## Item 8.

### Post Exhibition - Planning Proposal - Sydney Metro West Hunter Street Station Sites, Sydney - Sydney Local Environmental Plan 2012 Amendment

File No: X089148

**Figure 5:** Survey plan of the former Hunter Connection retail arcade detailing connections between George Street and Wynyard Station to Hunter Street and the 109 Pitt Street building

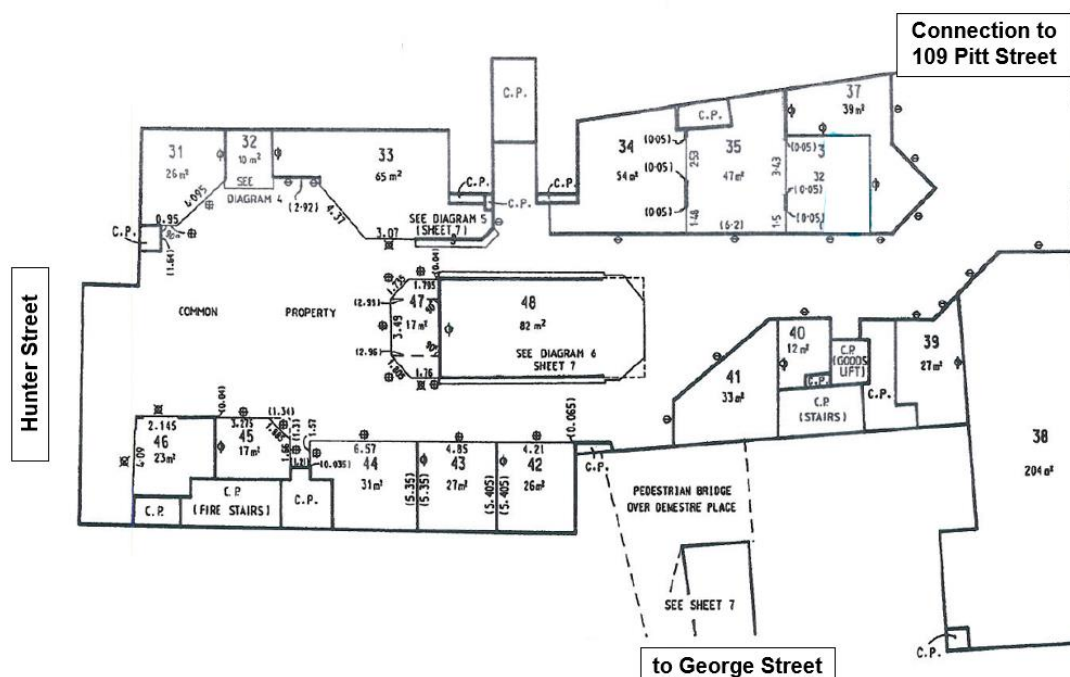
- 19. Sixteen submissions were received from the landowners of 109 Pitt Street which adjoins the west site along its eastern boundary. The submissions raised concern that there is no guarantee that future development would be connected with 109 Pitt Street, reinstating the previous pedestrian link to the Hunter Connection retail arcade, which provided underground connections from Pitt and Hunter Streets to Wynyard Station, through what is now the west site.

20. Submissions noted that the failure to reinstate this connection would adversely impact the existing retail spaces in the 109 Pitt Street building and would not achieve the stated aspirations for the project in creating a pedestrian precinct, impacting accessibility and the local retail economy around the subject site.

21. Hunter Connection comprised retail tenancies, a food court and an underground and protected link between Wynyard Station, Hunter Street and Pitt Street through the 109 Pitt Street Building. The Hunter Connection building was acquired by Sydney Metro and forms part of the future Hunter Street Station western site.

22. An objective of the Design Guidelines is to “Improve permeability, pedestrian movement and connectivity with the provision of generous retail activated through-site links”. The provisions detail the locations of future through-site links for greater permeability, movement and connectivity, and to reinstate existing and historical connections.

23. The below figure from the draft Design Guidelines shows the location for future through-site connections from the western site. As shown, it is recommended a connection is maintained into the 109 Pitt Street site (shown in blue outline), maintaining links to this section of the former Hunter Connection.

24. The indicative design that accompanies the concept SSDA includes through-site links, demonstrating the subject sites are capable of incorporating pedestrian connections as detailed in the Design Guidelines. This will be further resolved through the detailed design and development application stages where issues relating to level alignment and heritage will need to be resolved. The City will continue to advocate for the detailed design to address this provision. It is recommended the owners of 109 Pitt Street continue to actively engage with Sydney Metro and the Department of Planning and Environment to ensure this pedestrian link is reinstated.
